**Interpretation Number:** 1-11/09  
**Topic:** Specifications of allowable inter packet gap values in IEEE 802.3  
**Relevant Clause:** Clause 4  
**Classification:** Request for Interpretation

### Topic: Specifications of allowable inter packet gap values in IEEE 802.3

## Interpretation for Specifications of allowable inter packet gap values in IEEE 802.3

**Figure 1: Basic network scenario and LAN CSMA/CD layer structure including repeater set reference model of Gigabit Ethernet (1000-Mb/s operation)**

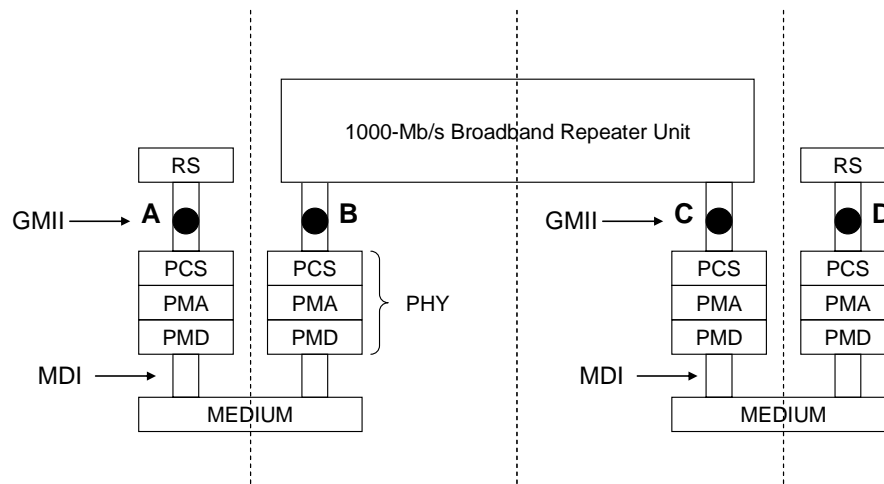
*At which point is the allowable IPG value (96 bits) in the table of 4.4.2 specified? (GMII in GbE case?) Figure 1 shows a basic network scenario and LAN CSMA/CD layer structure that includes a 1000-Mb/s repeater unit. According to Note3 below the table in 4.4.2, IPG values*

*seem to be regulated at GMII at the DTE. Point A seems to be applicable; however, points B, C, and D do not seem to be applicable. There do not seem to be clear descriptions in the main body*

*of 4.4.2 regarding at which point the values are regulated.*

The standard is unambiguous. Sub clause 4.4.2, Table 4-2, defines the value of the constant 'interPacketGap' for the various MAC data rates. As stated in sub clause 4.2.7.2 'Transmit state variables' the constant 'interPacketGap' defines the 'minimum gap between packets'. Sub clause 4.2.8 'Frame transmission' in 'process Deference' uses the constant 'interPacketGap' in full duplex operation, and the constants 'interPacketGapPart1' and 'interPacketGapPart2' derived from the constant 'interPacketGap', in half duplex, to control the minimum transmit gap between packets from the MAC. The use of the constant 'interPacketGap' to control the minimum gap between packets is further described in sub clause 4.2.3.2.1 'Deference'.

The 96 bit value defined in sub clause 4.4.2 therefore applies at MAC transmit, which is defined at the PLS service Interface. In the specific case of 1Gb/s MAC data rate, since the Reconciliation Sublayer (RS) does not define any allowed change in the value of the Inter-Packet Gap this value also applies at the GMII in the transmit direction. Note that this is not necessarily true for all other MAC data rates.

**Figure 2: One example of GbE connection through OTN including GFP-T section**

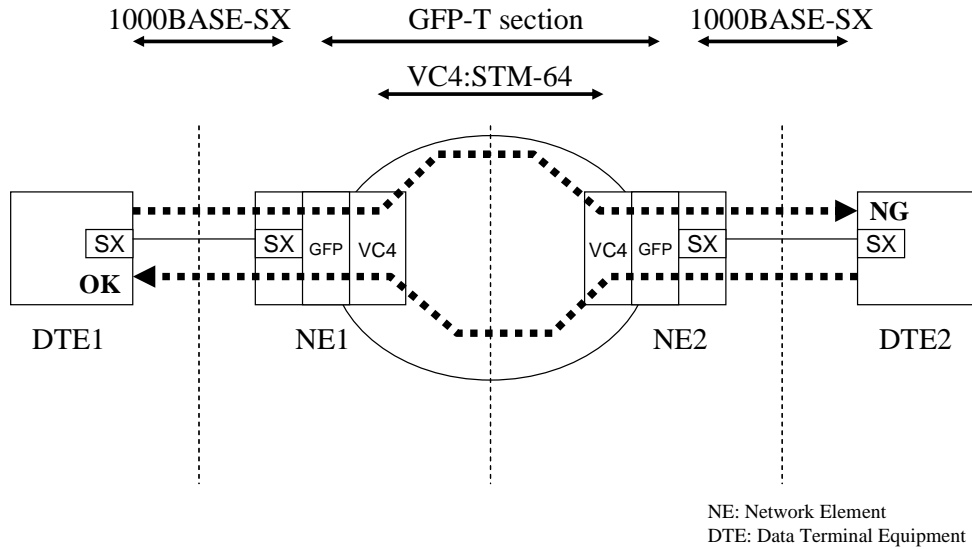
First, we need to consider IPG shrinkage in 2-byte units. We would like to consider the rate adaptation process specified in G.7041. If there is frequency deviation between the output signal from DTE1 and input signal to DTE2, rate adaptation needs to be applied. Then, NE1 and NE2 can be regarded as repeater, and the maximum frequency deviation is 200 ppm, according to Table 38–3 in IEEE 802.3. For example, when the output signal from DTE1 is +100 ppm and the input signal from DTE2 is –100 ppm, the IPGs have to be removed using rate adaptation. The client-specific rate adaptation is specified in section 8.4.1.2.4 in G.7041. The minimum unit that can be removed from a GbE signal is  $/I2/$ , which is one of the 2-byte order sets. Therefore, if the frequency offset of the DTE1 output signal is larger than that of the DTE2 input signal, a 2-byte Idle removal has to be done for rate adaptation at certain intervals.

For example, assuming that relative frequency deviation between input and output signals is +200 ppm, that is, when the output signal from DTE1 is +100 ppm and the input signal from DTE2 is –100 ppm, if the packet size is 1518 bytes with a continuous 12-byte IPG interval, the probability of a 2-byte IPG shrinkage per one frame cycle (=1538 bytes) will be about 15%  $(= (1518: \text{data} + 8: \text{preamble} + 12: \text{IPG}) \text{ bytes} \times 200 \text{ ppm} / 2 \text{ bytes} / 100)$ . This means that the size of an IPG in a GbE signal can change from 12 to 10 bytes at certain intervals. The actual size of the IPG seems to show some distribution because of clock tolerance. The point here is that IPG shrinkage could happen in 2-byte units for rate adaptation irrespective of the size of the frequency difference if there is a frequency deviation.

Second, we need to further consider the IPG shrinkage by 8-bit. According to the description in section 41.2.1.3.2 and B.1.5.3, a repeater set seems to be able to remove IPG because of “Preamble

regeneration”. This might happen at point C in Fig. 1. Therefore, additional removal of 8-bit IPG seems to be able to be designed in the GFP-T section.

It is estimated that the 24-bit IPG might be removed when the two above cases of shrinkage are simultaneously applied in the intermediate NEs. Moreover, there is no description about the 8-bit guard band in the formal IEEE 802.3 standardization, it is also estimated that the total 32-bit IPG might be removed. If the receiver side can not receive a GbE signal correctly, it leads to packet losses. Therefore, we need to design or guarantee the allowable IPG size at NEs.

We tested the network scenario in Fig. 2 in our laboratory; GbE traffic was sent from DTE1 to DTE2 and also from DTE2 to DTE1. As a result, packet loss was detected once per few minutes in the direction of DTE1 to DTE2 and not in DTE2 to DTE1. The traffic rate was 990 Mbps in which IPv4 (64, 256, 1518 bytes): 495 Mbps and IPv6 (82, 256, 1518 bytes): 495 Mbps were mixed. In this case, the received IPGs at the DTE2 can be minimum 64-bit, because the NE2 can send 64-bit IPGs to the DTE2, following the Note3 of table in section 4.4.2 of IEEE 802.3.
